REV.	DATE	AMENDMENT
P01	30.10.2020	Issued for Planning
P02	15.09.2021	NMA Changes
P03	12.11.2021	NMA Updates

PROJECT
New Victoria

General Arrangement
Lower Ground Floor Plan

STATUS	PURPOSE FOR ISSUE	SR NO.
S2	PLANNING	6621
DRAWING NO.	REV.	
VIC -SRA-AL 00L DR - A - 20899	P03

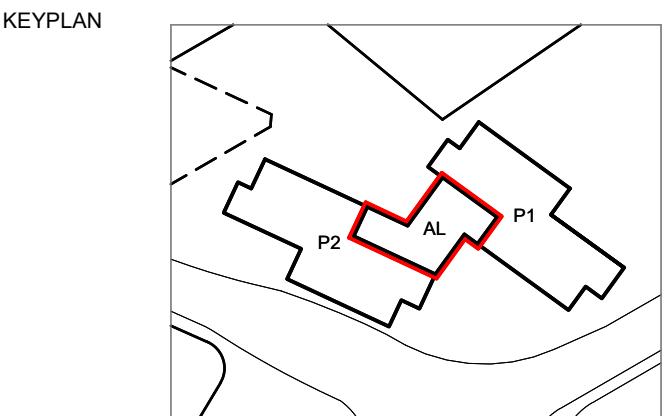
GRC column encasements
to match facade

Door Increase

Door and Lobby
Change

Shear wall removed and
replaced with columns

Change in door size and
glazing change to opaque

GRC Column
cladding added

Shear wall removed and
replaced with columns

Additional Louvers

GRC extended
around columns
and shear wall

Shear Wall removed
and columns
reconfigured
